Product Change Notification (PCN)

PCN #: 8D-2025 Date: August 19, 2025

2 Description of Changes

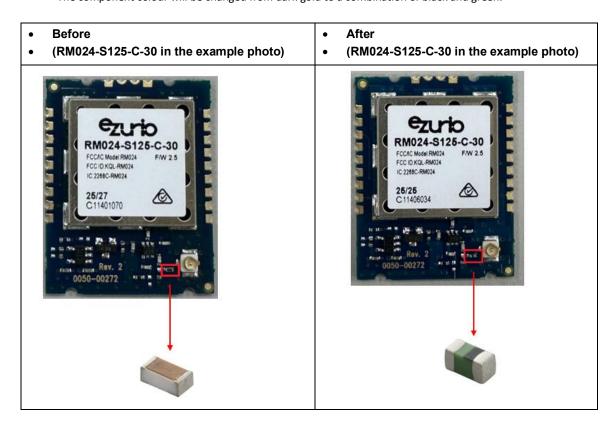
- Murata LQP15MN2N4B02D is going to End Of Life (EOL) and enter EOL control. Murata LQG15HS2N4B02D is a compatible pin to pin
 alternative part.
- Murata LQP15MN2N0B02D is going to End Of Life (EOL) and enter EOL control. Murata LQG15HS2N0B02D is pin to pin compatible alternative part.

The Murata LQP15MN2N4B02D and LQP15MN2N0B02D have been made EOL by the vendor. To continue mass production of the Ezurio products affected, it requires migrating this EOL component to Murata LQG15HS2N4B02D and LQG15HS2N0B02D, which are a pin-to-pin compatible alternative.

- The component colour will be changed from dark gold to a combination of black and green.
